Subject: AP1000 COL Response to Requests for Additional Information (TR 3)

## Response to Request For Additional Information (RAI)

RAI Response Number: RAI-TR03-015  
Revision: 1

Figure C-1 – FRS Comparison at Base of SCV on CIS at RPV Center

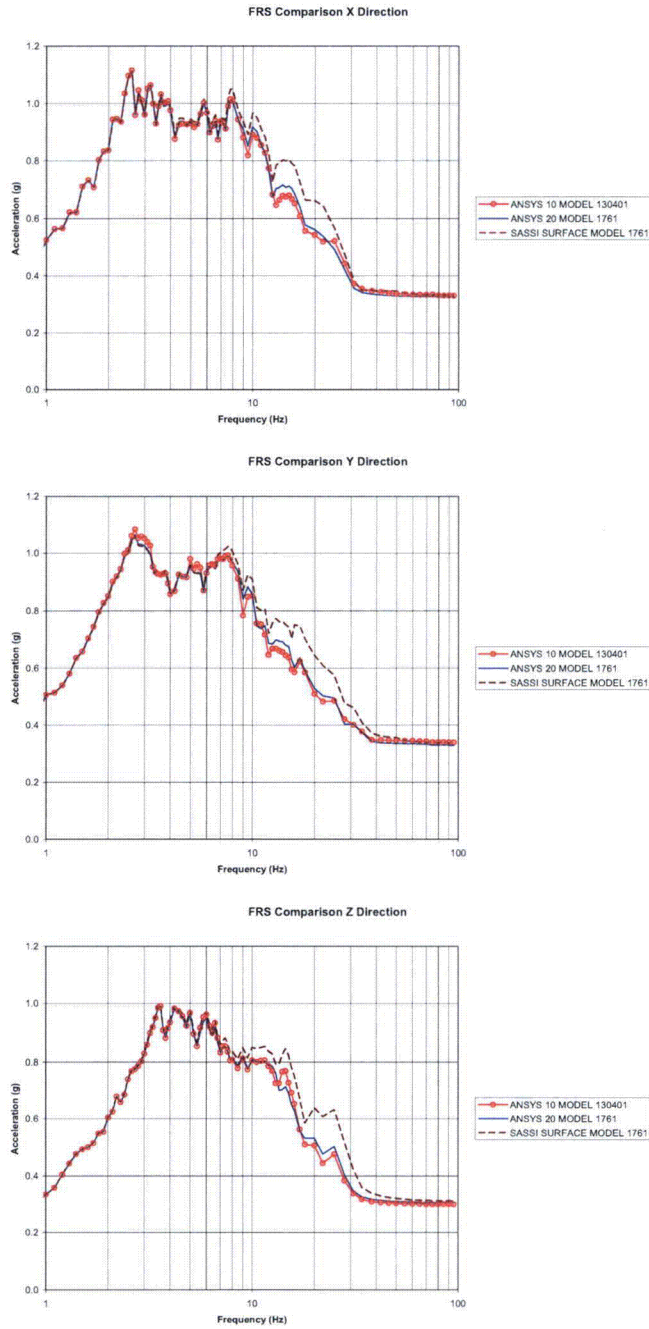
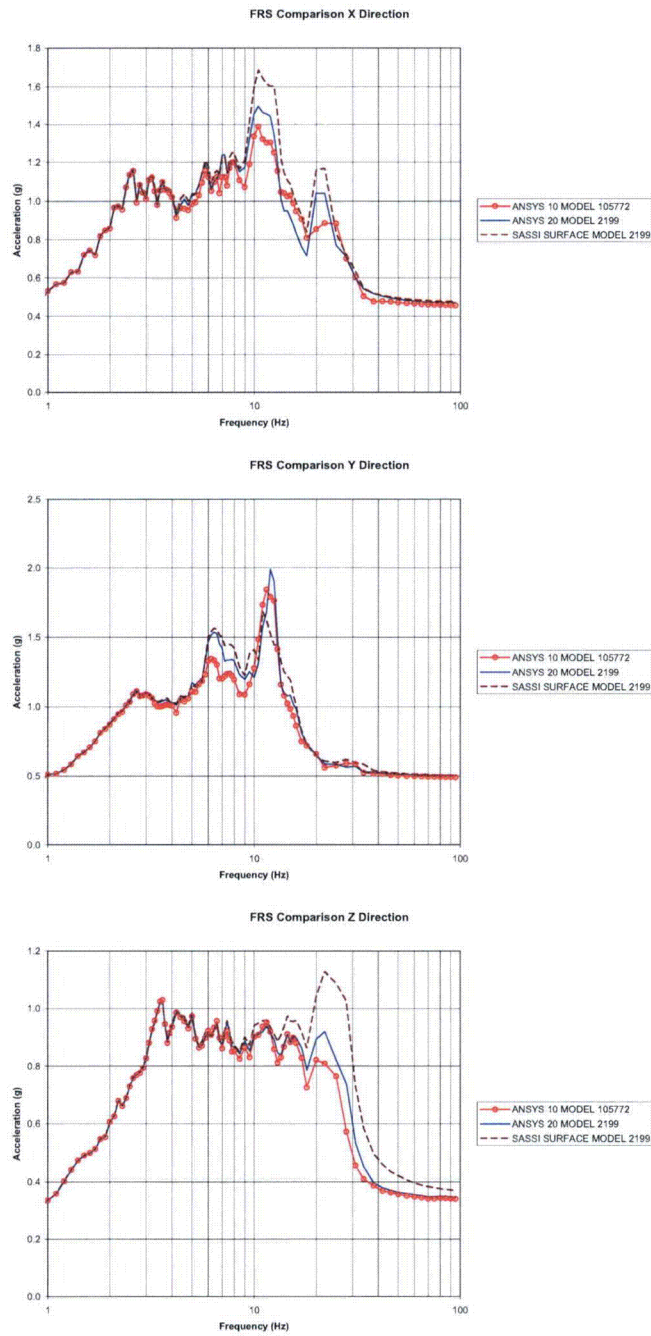
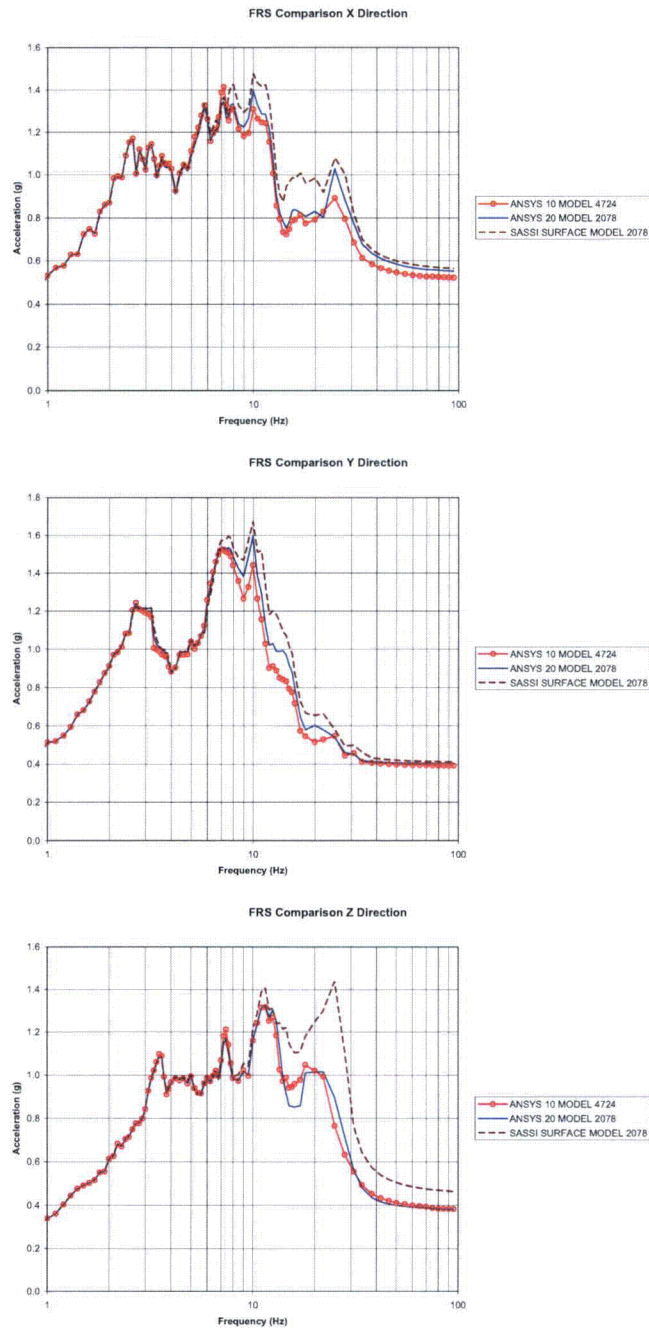
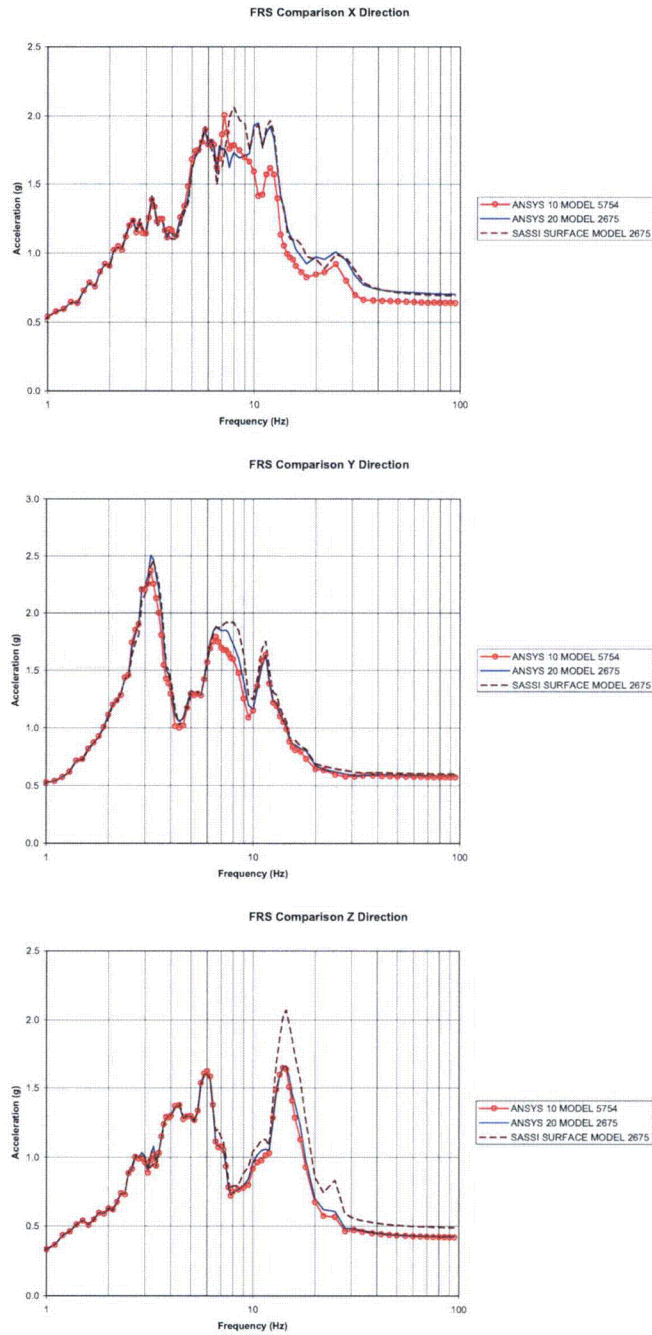
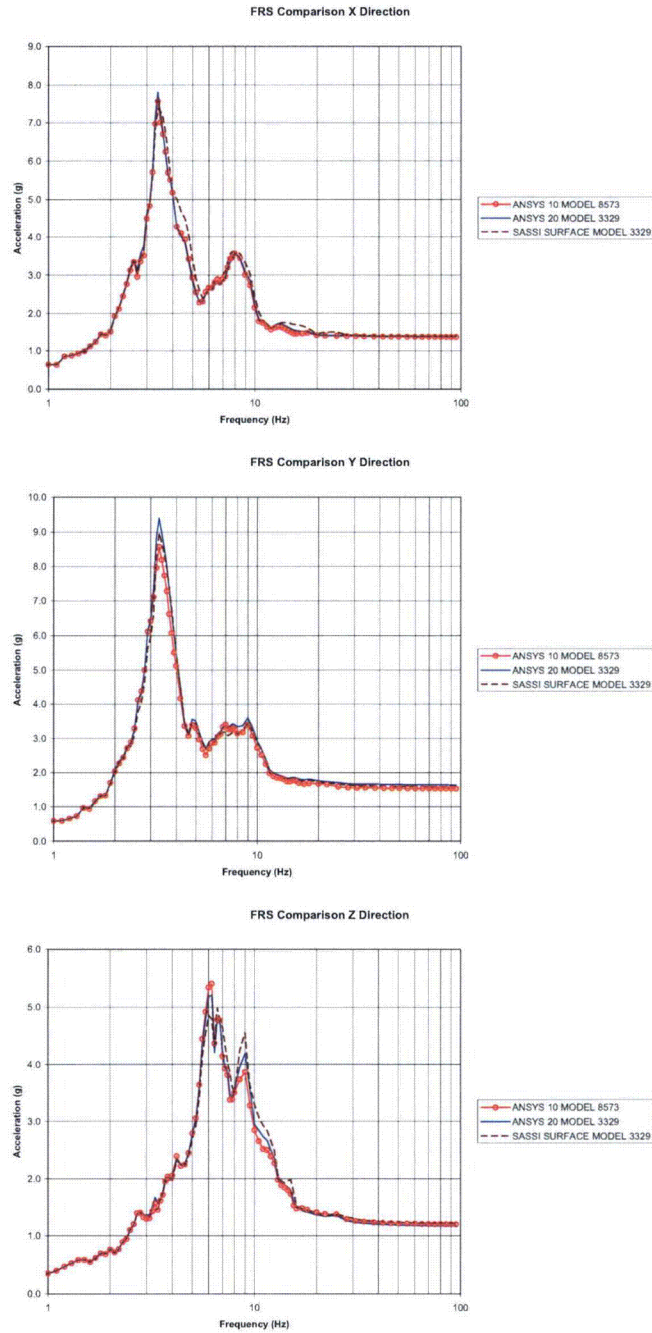
- c. Explain what studies were performed to establish that the NI10 model refinement is sufficient to accurately account for high frequency response effects at all critical locations. It is not obvious from the results shown in Figure C-1 that convergence with element size has been achieved.

Figures C-1 to C-6 compare response spectra for ANSYS analyses of the NI10 and NI20 models at the interface seismic response key nodes (see Section 4.4.3). These locations are given in Table C-1. Also shown in this table are the figures where the comparison spectra are given. Both finite element models give comparable results below 10 hertz. However, the results from the coarse model are not as good at high frequencies (above about 15 hertz). Therefore the hard rock FRS were generated from the fine NI10 model, and the coarse NI20 model was used for the soil site analyses where frequencies of interest are below 10 hertz.

As seen from the comparison (see Figures C-1 to C-6), for the horizontal response, the SASSI and ANSYS results for NI20 are very similar to about 15 Hz horizontal and about 10 Hz vertical. At the higher frequencies SASSI calculates higher accelerations. The NI20 model uses solid elements for the mass concrete below grade inside the shield building. Other parts of the model use shell elements. The difference in ANSYS and SASSI results is most noticeable at the three
